LOCAL GOVERNMENT NEW ZEALAND TECHNICAL ASSISTANCE FACILITY

Tokelau

Building Control

25 August – 11 September 2019

Hospital

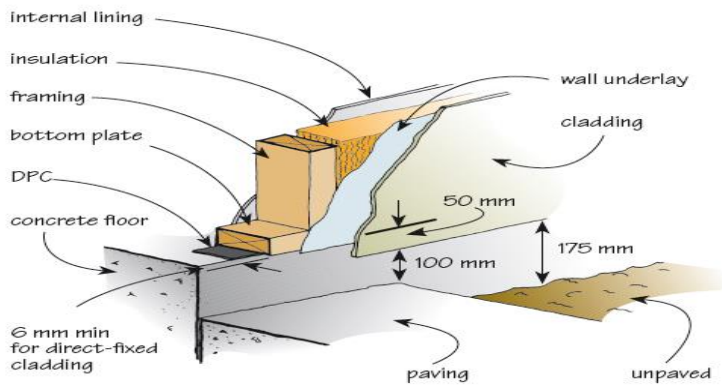
- Fibre cement cladding has been installed with no ground clearance. This has the potential for moisture to be drawn up into the cladding, which can lead to the cladding delaminating.
- Head flashing installations to the aluminium windows are incorrect and will not provide the intended protection against water ingress.

1. Head flashings should be installed, so that the face of flashing fits closely up against the face of aluminium window, as per the figure below.
2. Cladding systems should be installed to meet the requirements of the manufacturer, and this should be documented during the approval stage of the proposed work. As a general rule, cladding should have a minimum clearance of 100mm from a paved area or 175mm from unpaved areas – see figure below.
3. Sill blocks should be used in any future blockwork buildings as per Figure E3.15 Tokelau Home Building manual Vol 2.

Jacinda Ardern Accommodation

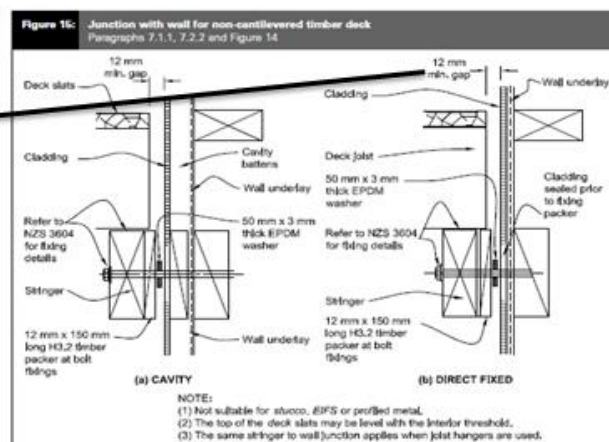
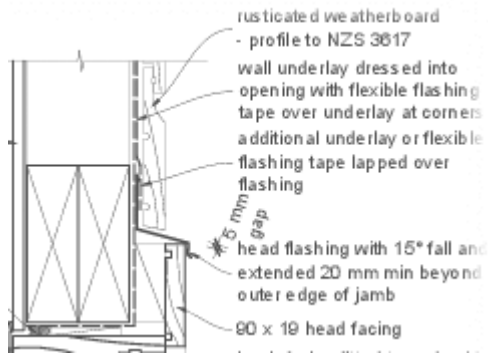
This building was still being completed but was up to a good standard of construction with design features that will provide protection from the weather. Head flashings had not been installed to the windows but this was mitigated by the installation of facings around the window, and the protection provided by the verandas.

The upper level deck has been installed hard up to the cladding. This should have a drainage path (see below photo with detail from the New Zealand building code acceptable solution).

1. Install head flashing as per detail below, or at the very least, in place of a metal flashing, an exterior silicon sealant should be applied to the top the head facing, to provide extra protection. Ensure decks attached to building have a 12mm gap to allow water to drain.

School building

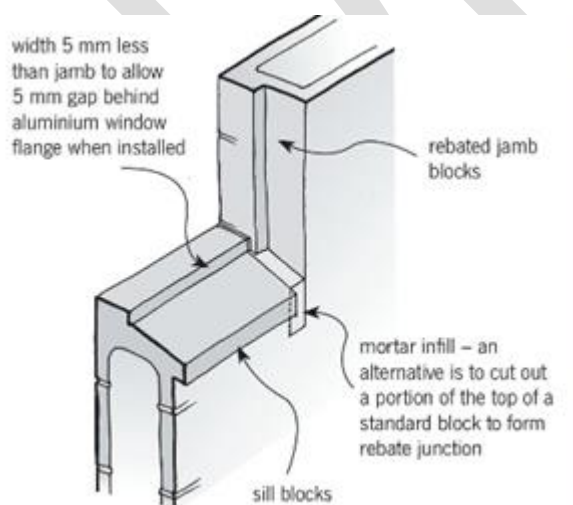
The school has a major weather-tightness issue that causes the building to flood during heavy rain, and has the potential risk of injury to staff and students, from slipping on the wet tiles.

Both of these issues are due to poor design, as there is no protection from the prevailing weather from the seaward facing side of the building, and poor construction methods.

1. Installing window facings and applying an external plaster system, to provide a waterproofing coating to the blockwork, should address/reduce the weather-tightness issue if applied correctly.
2. I would also recommend that the seaward facing side of the building have a veranda installed that mirrors the other side of the building, as this will help protect the cladding system being exposed to water penetration.

Sill blocks should be used in any further blockwork buildings.
